Ref.: AN 4/1.1.58-23/32

Subject: Proposal for the amendment of Annex 14,
Volume II concerning heliport specifications

PROPOSED AMENDMENT TO ANNEX 14, VOLUME II

**VOLUME II
(HELIPORTS)**

Figure 5-1211. Isocandela diagrams

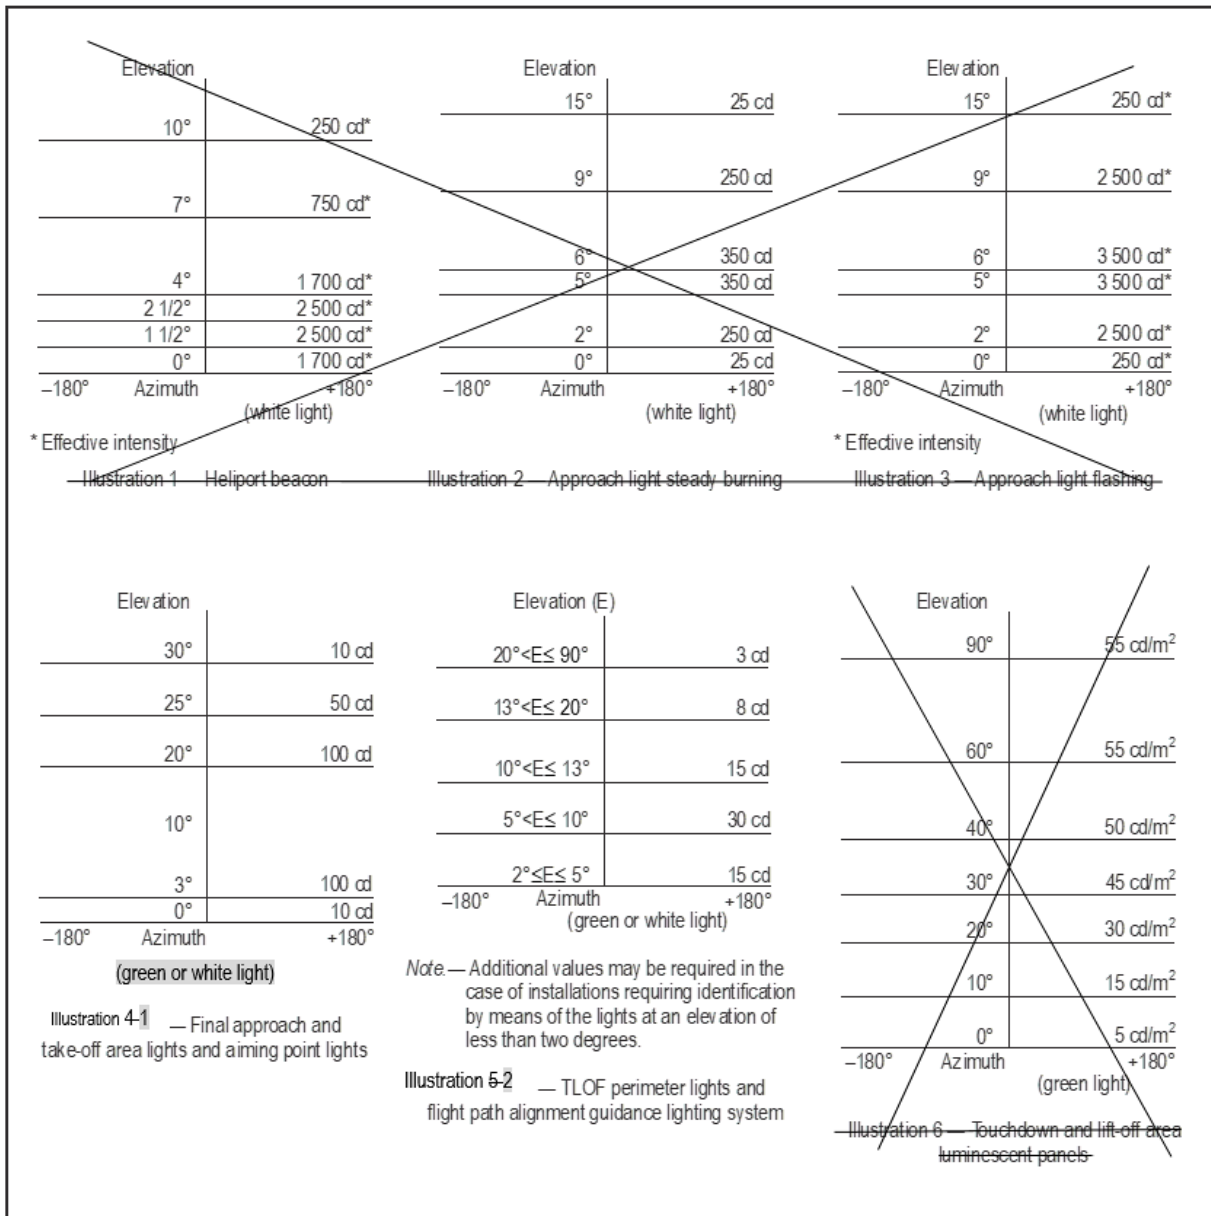
5.3.4.6 **Recommendation.**— *The distribution of the lights should be as indicated in Figure 5-12~~1~~, Illustration 5~~2~~.*

5.3.7.4 **Recommendation.**— *The light distribution of FATO perimeter lights should be as shown in Figure 5-12-I Illustration I-4.*

5.3.8.4 **Recommendation.**— *The light distribution of aiming point lights should be as shown in Figure 5-12-I, Illustration I-4.*

5.3.9.1622 **Recommendation** — *The light distribution of the perimeter lights should be as shown in Figure 5-121, Illustration 25.*

<i>Origin:</i>	<i>Rationale:</i>
HDWG/14 ADOP/4	Update to provide both green or white colour options for FATO lights. The detailed specifications for Helipoint Beacon, approach lighting systems and related illustrations one to three and six, are transferred to the <i>Helipoint Manual</i> (Doc 9261).
